**BICESTER TO OXFORD TRANSPORT AND WORKS ACT ORDER
(TWA/10/APP/01)) - DISCHARGE OF CONDITION 19 (VIBRATION
AND NOISE) AS IT RELATES TO SECTION H**

Annex 1 - Atkins Drawing No 5114534-ATK-DRG-MD-790203 Rev P01

WOLVERCOTE AREA
S&C GEOMETRY
CH 125473 TO CH 125607

East West Rail Phase 1: Vibration Assessment for Proposed Relocation of Switches and Crossings in Section H

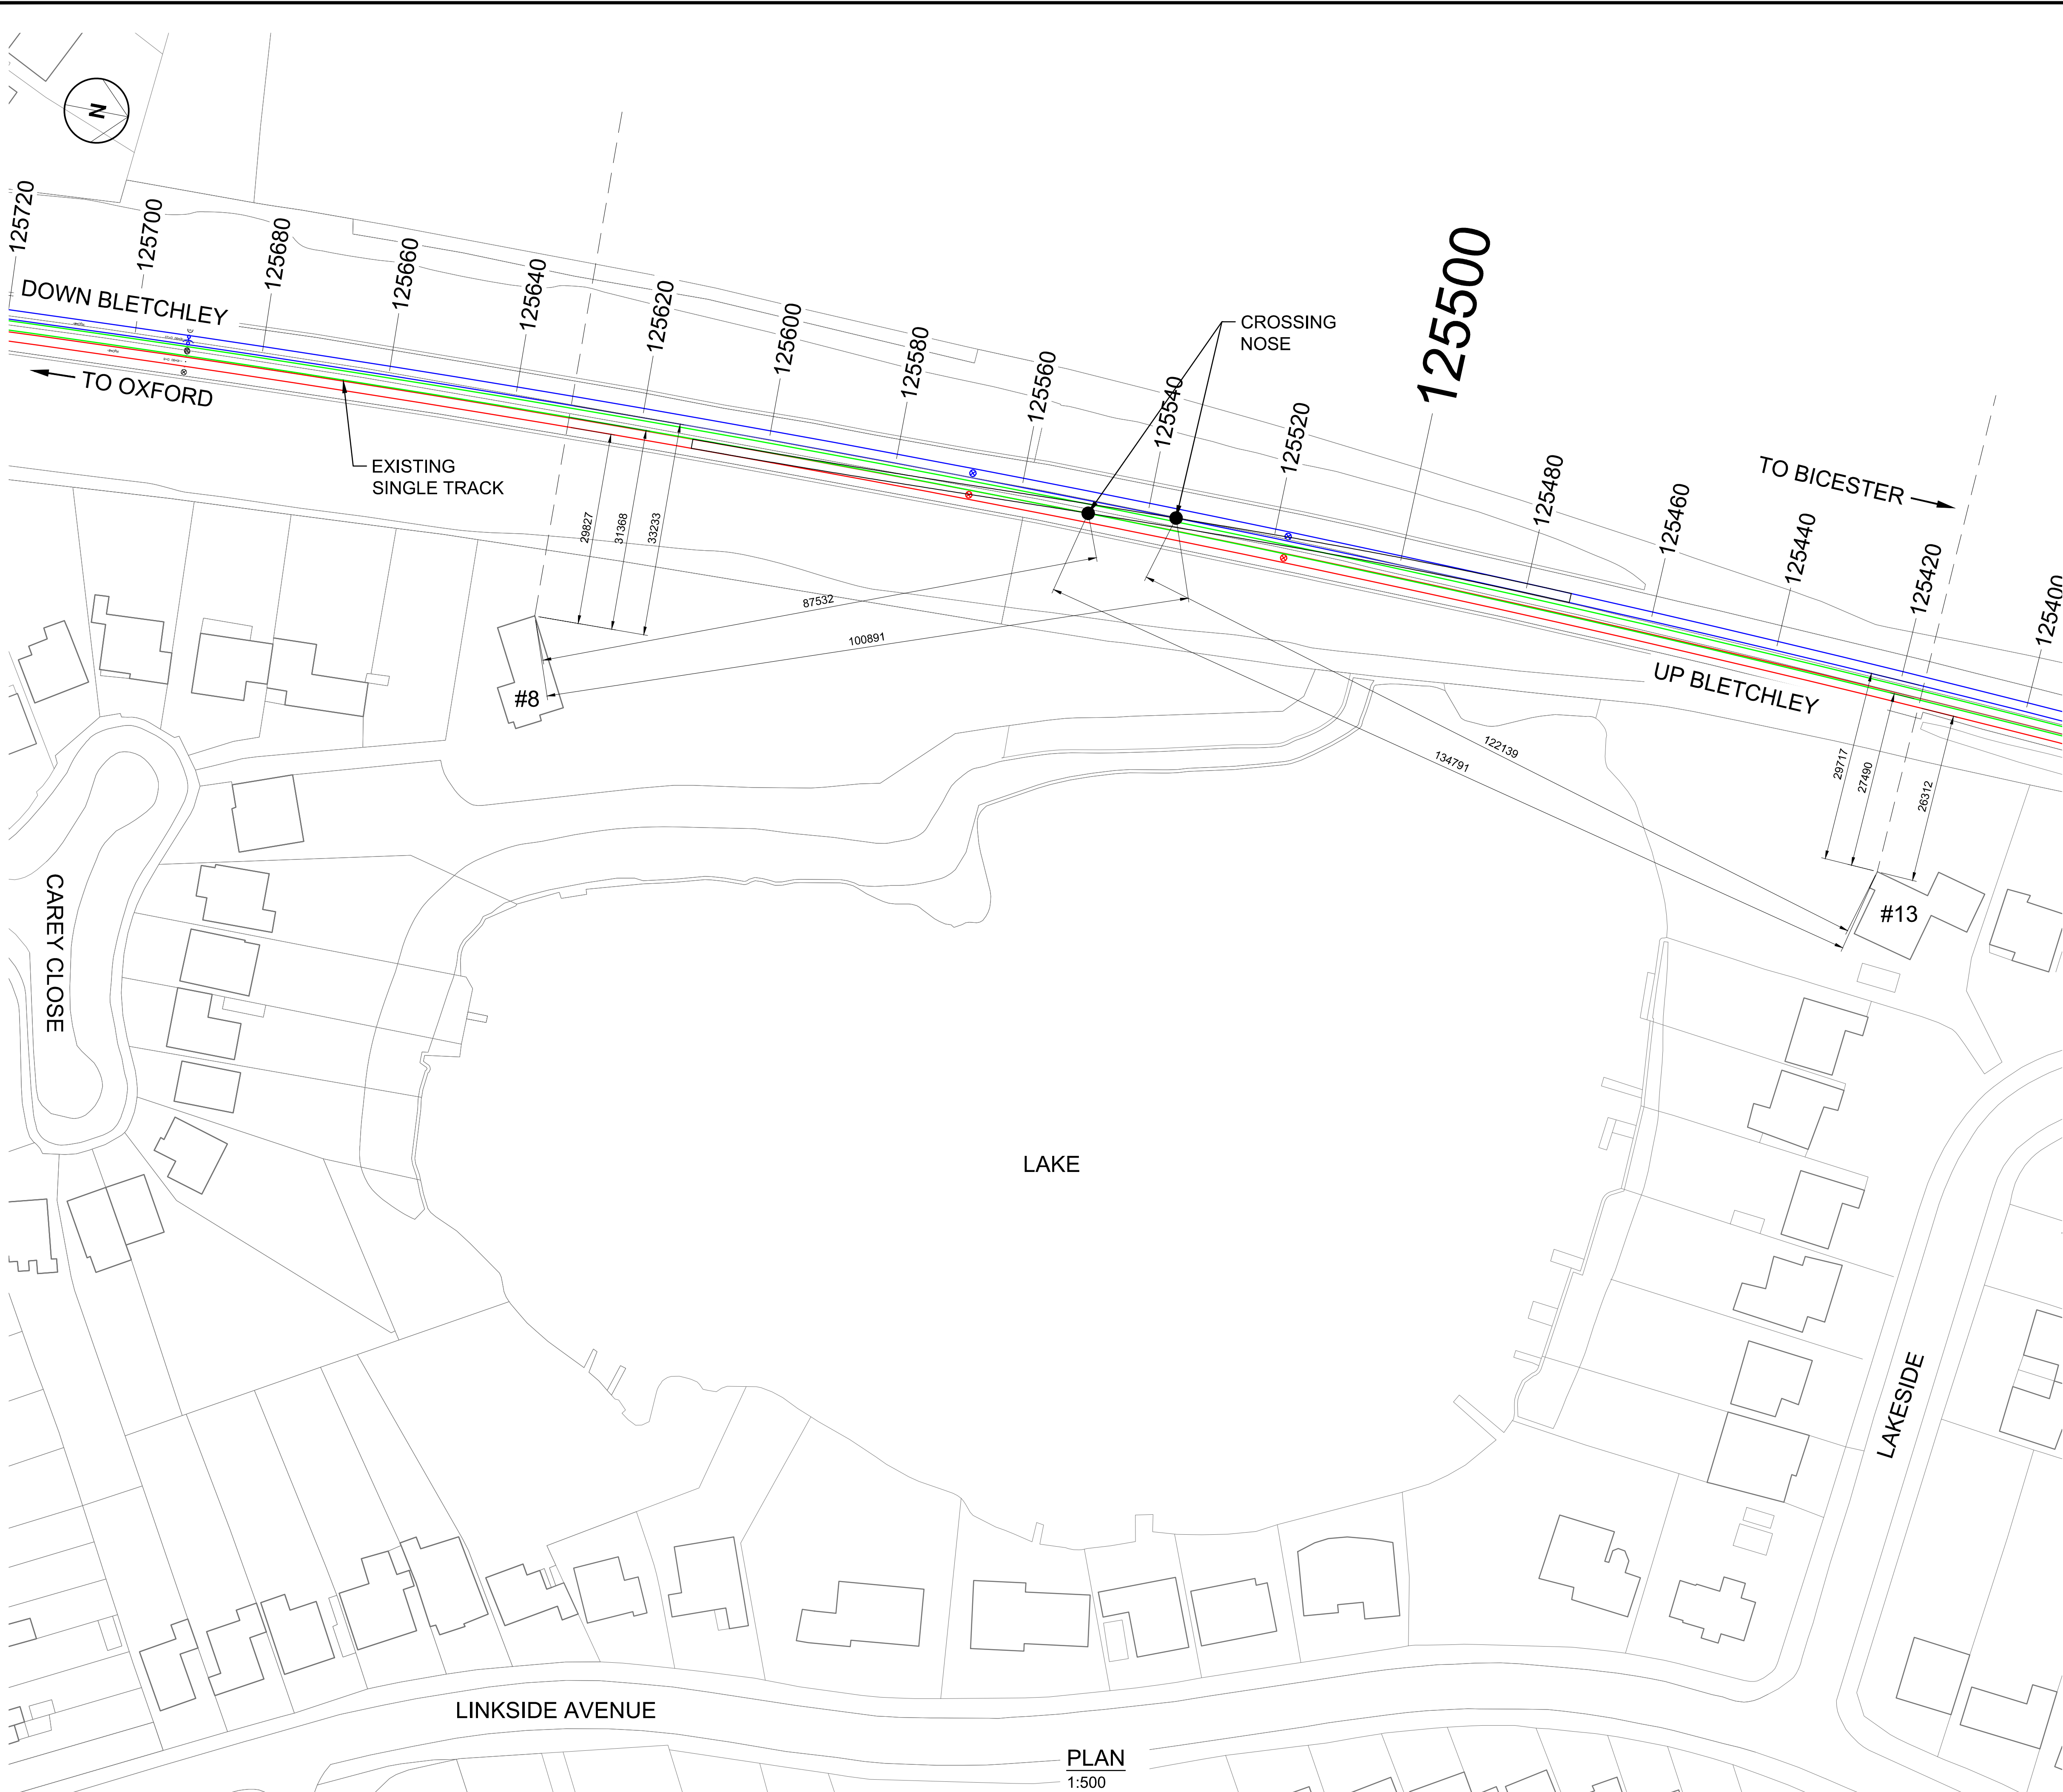
In order to secure approvals of the Vibration SoAs on 19 May, without recourse to speed limits, Network Rail is willing to agree not to install the proposed Switches and Crossing (S&C), which was proposed to be located in the vicinity of 4 Bladon Close (otherwise known as the Woodstock Road Crossover). The effect of this would be to bring the estimated Vibration Dose Values (VDVs) at 4 Bladon Close well within the Scheme limits during both day and night periods.

The Project now proposes to relocate the S&C to a position further north, but still within Section H, at Lakeside. The general layout of the proposed S&C is shown on Atkins drawing no 5114534-ATK-DRG-MD-790203 Rev P01 – chainage 125550, attached here as Annex 1. This location has been chosen in order to be well away from nearby residential (and commercial) properties.

Atkins has undertaken a further vibration assessment for the proposed relocation, attached here in full as Annex 2 (*East West Rail Phase 1: Vibration Assessment for Proposed Relocation of Switches and Crossings in Section H*). This assesses the potential vibration impacts on the nearest property to the S&C, which is identified as 8 Carey Close. This property is located approximately 87.5m and 100m south of the 2 relevant parts of the crossing.

The relocation of the S&C as outlined above will therefore address the potential exceedances at 4 Bladon Close, noted in Andy Milne's letter of 2 April 2015, and will not result in any adverse impacts at the new location, because of the much greater distances from the nearest residential property.
